**Eugene School District 4J
ROOSEVELT MIDDLE SCHOOL**
680 East 24th Avenue
Eugene, OR 97405
CIP No. 410.566.001

ADDENDUM NO. 1

This Addendum forms a part of the Contract Documents and modifies the original Bidding Documents dated February 18, 2015 as noted below. Acknowledge receipt of this Addendum in the space provided on the Bid Form. Failure to do so may subject the Bidder to disqualification.

A1 SECOND FLOOR PLAN - ZONE B - MECHANICAL
 1/8" = 1'-0"

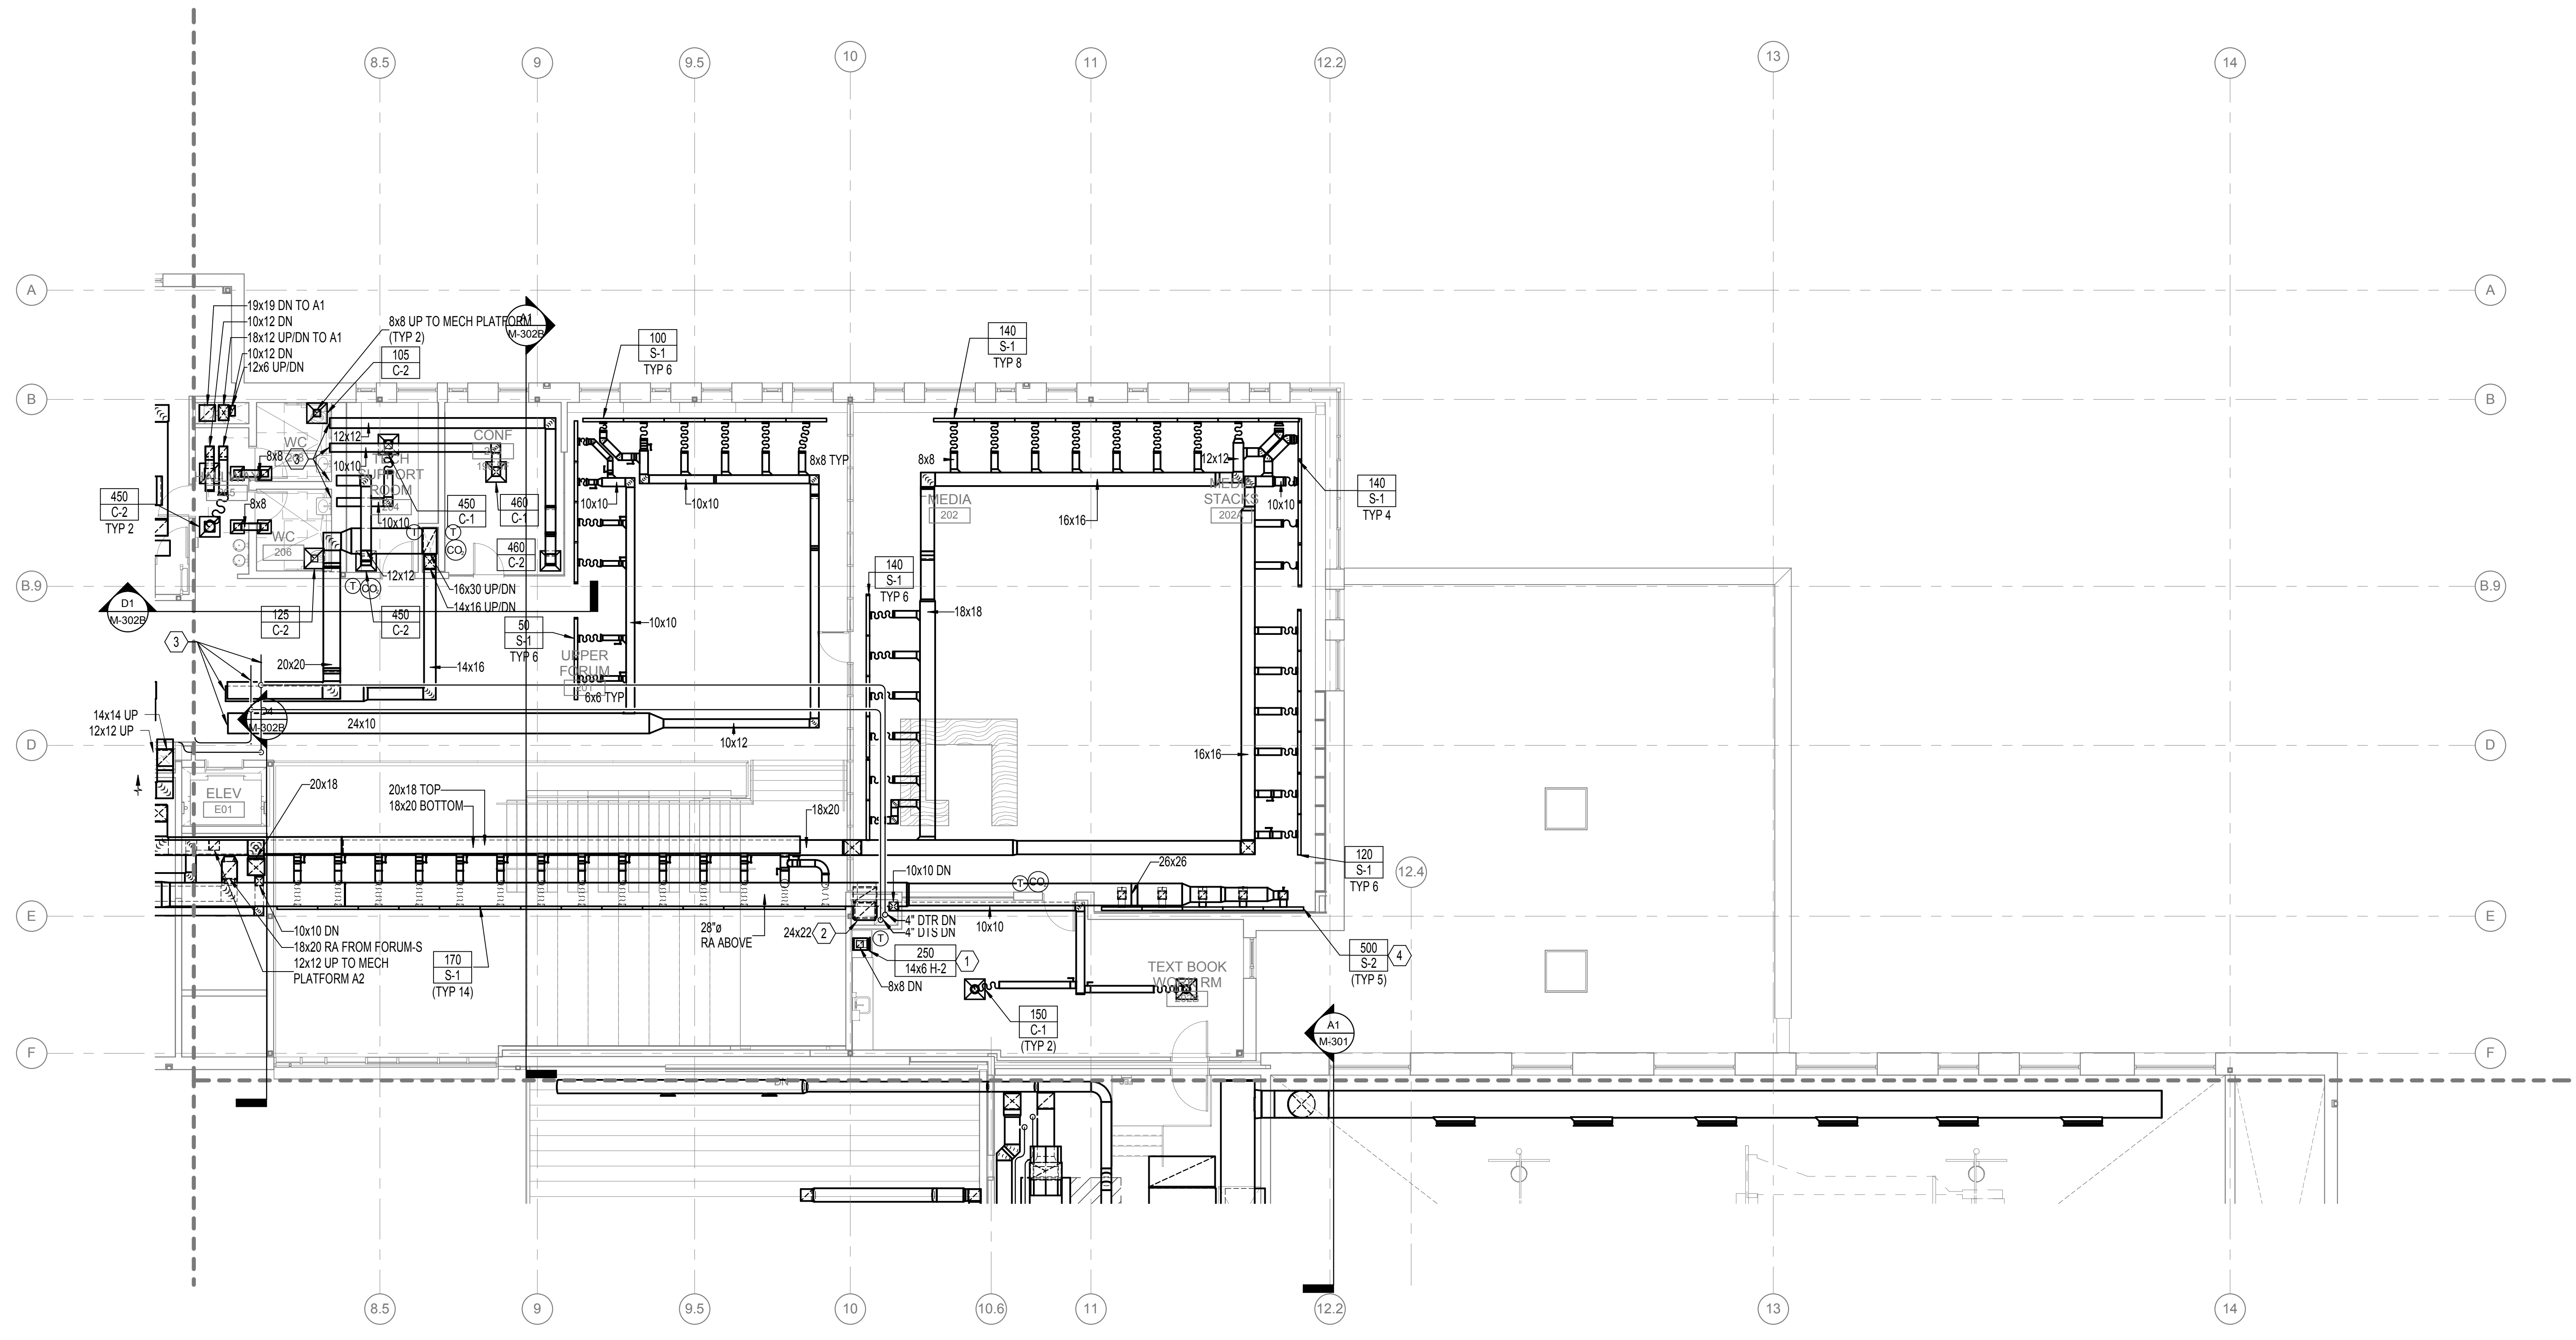
- A. Replace Sheet with attached new Sheet M-122B. Clarification: Note 2, added detail reference and revised perforated wood panel free area requirement.

A1 FIRST FLOOR PLAN - ZONE C - PLUMBING
1/8" = 1'-0"

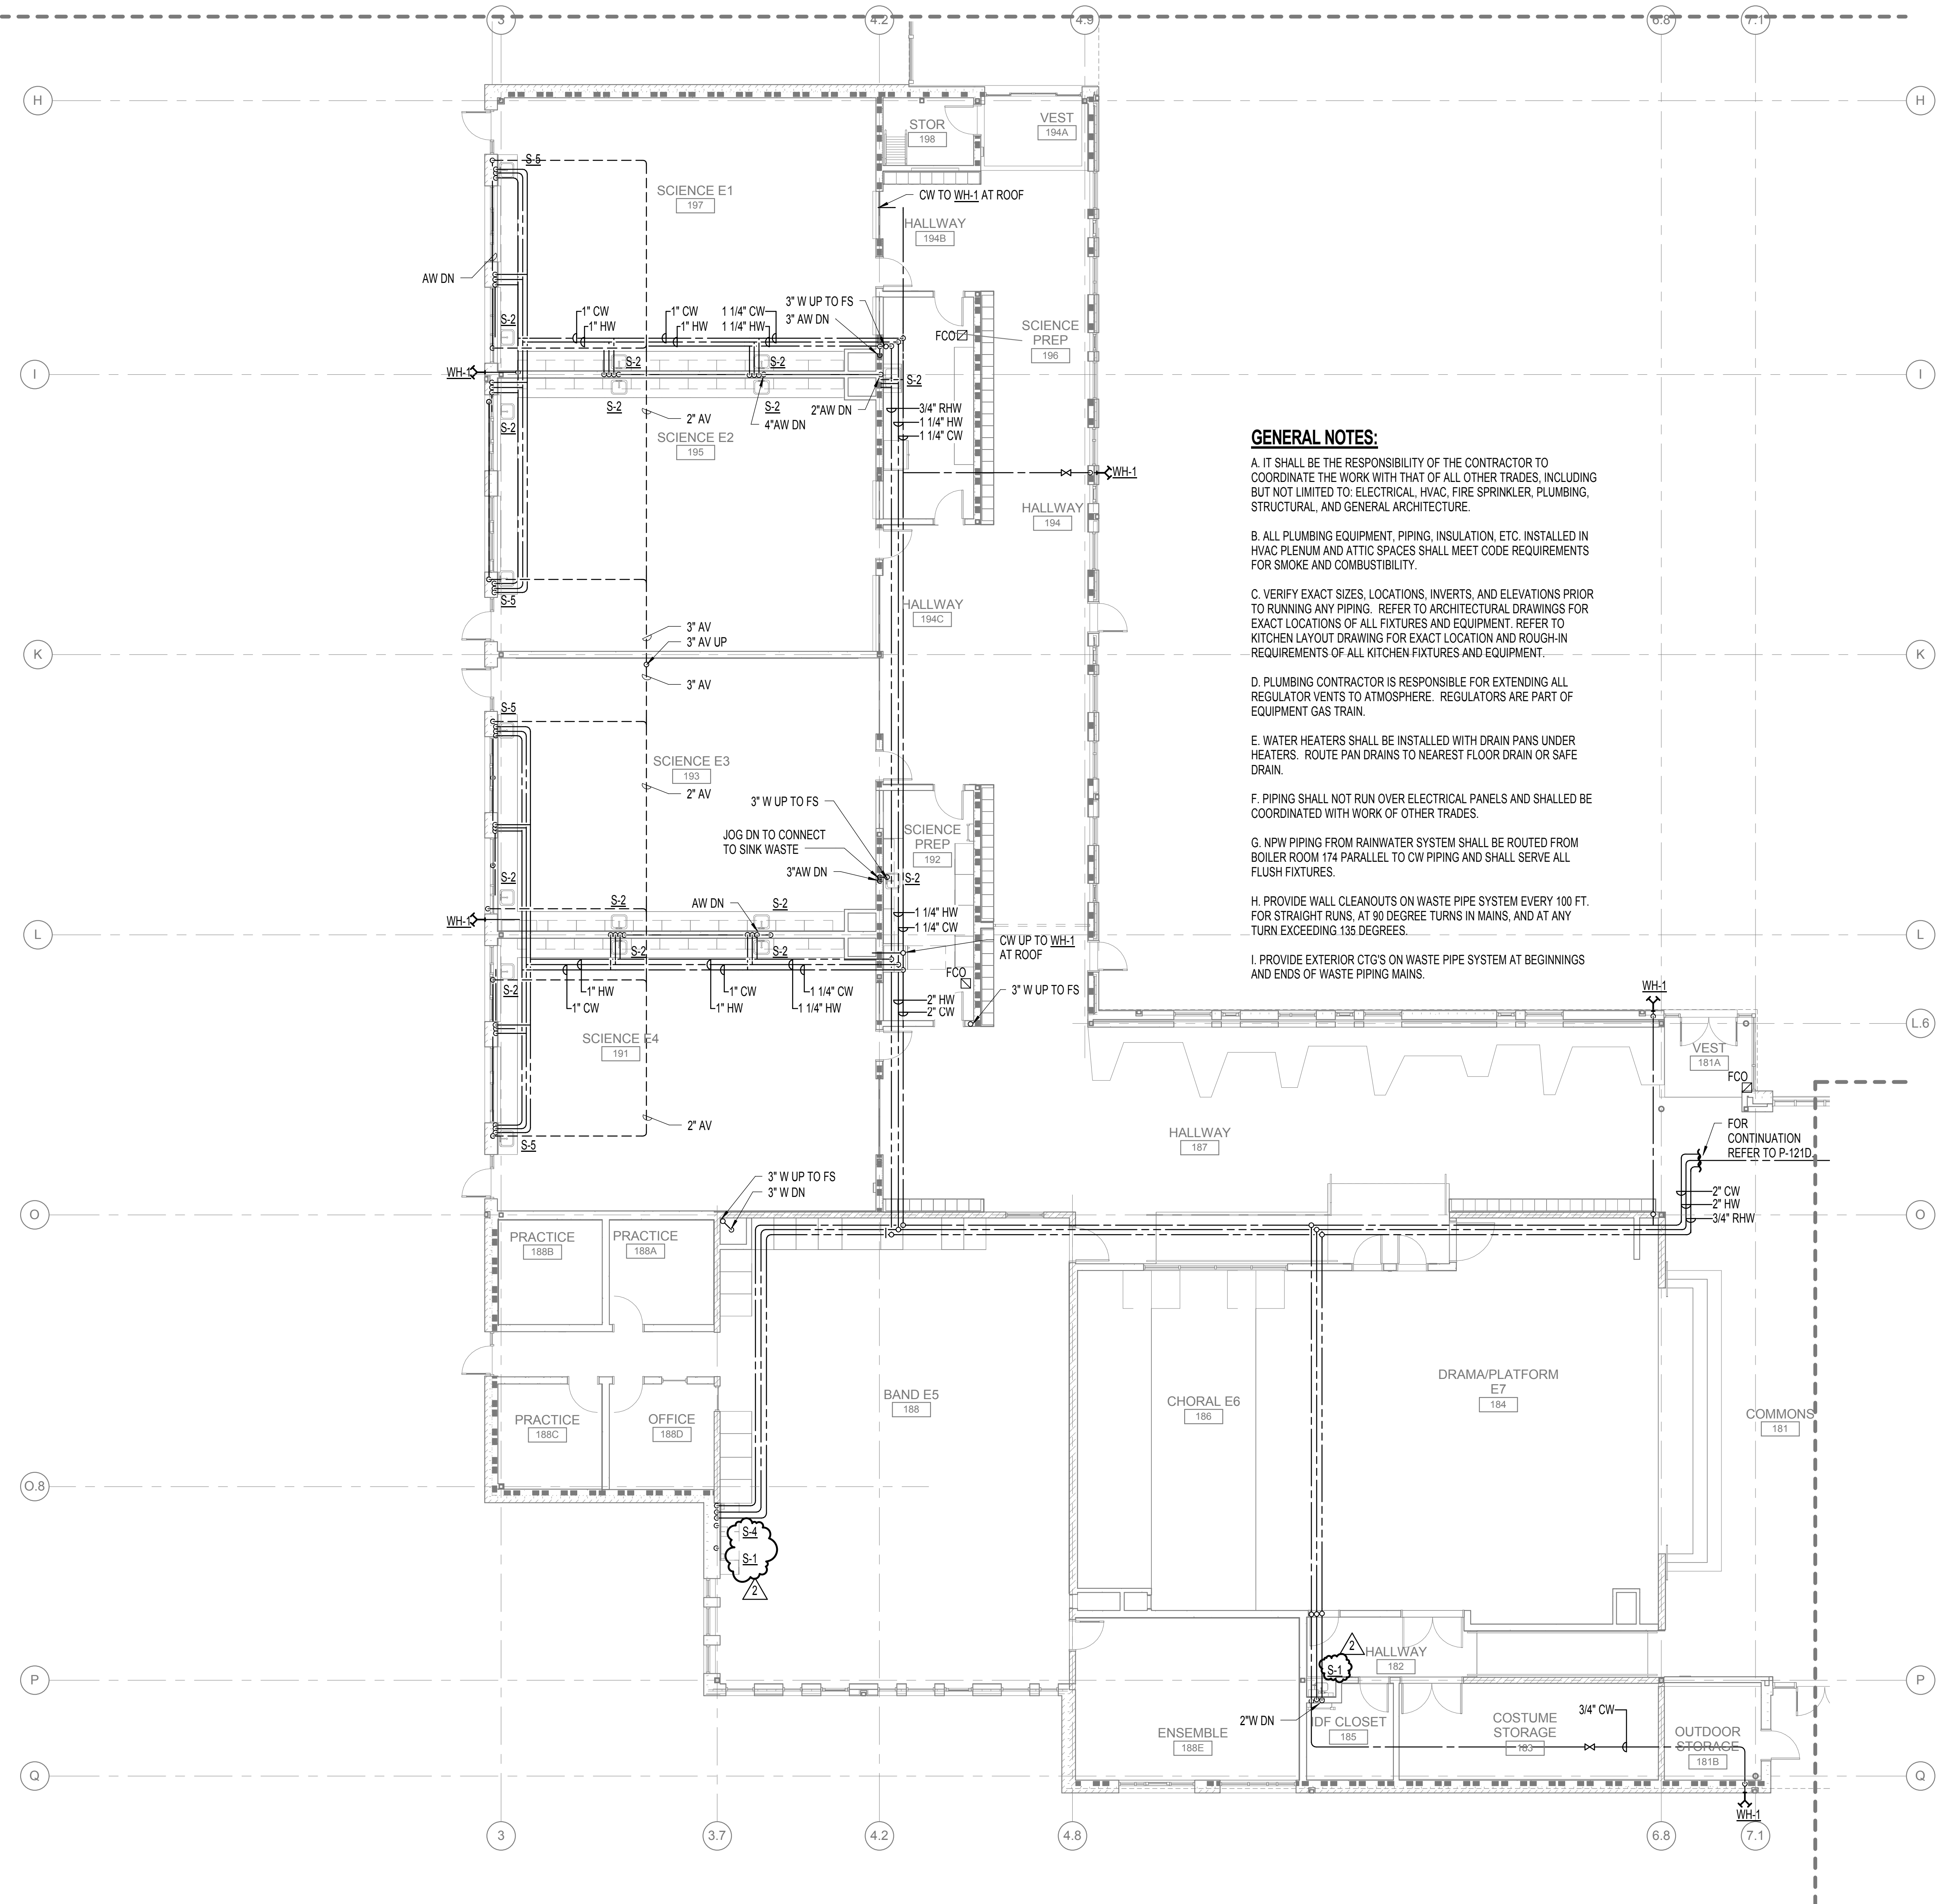
- A. Replace Sheet with attached new Sheet P-121C. Clarification: Changed sink tags in Clean Lab C3 and Dirty Lab C2.

A1 SECOND FLOOR PLAN - ZONE A - PLUMBING
1/8" = 1'-0"

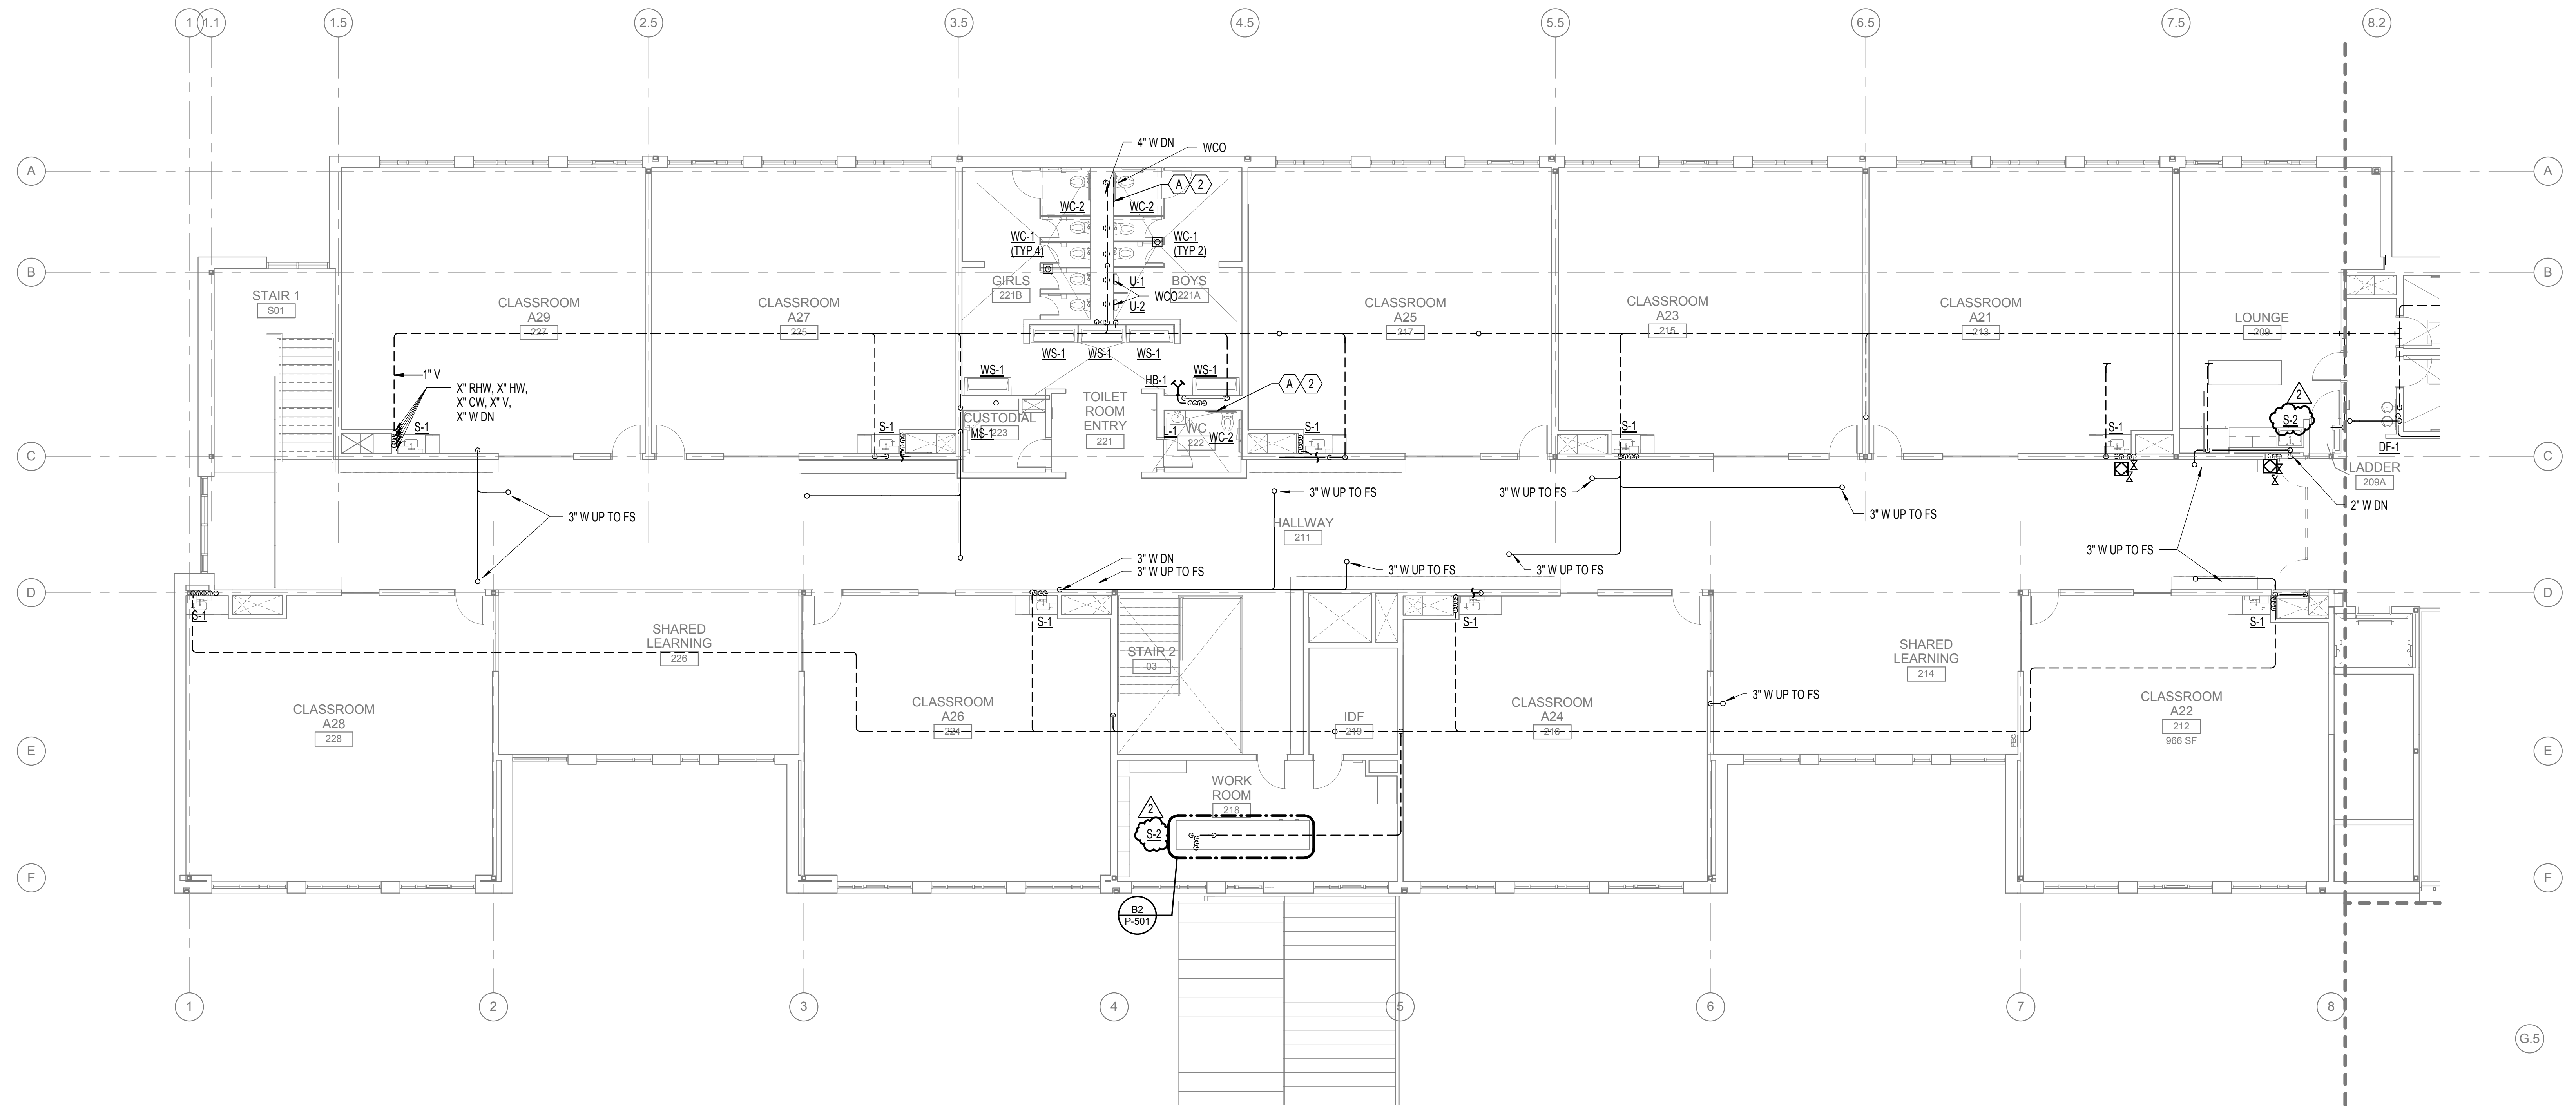
- A. Replace Sheet with attached new Sheet P-122A. Clarification: Changed sink tags in Lounge 209 and Work Room 218.
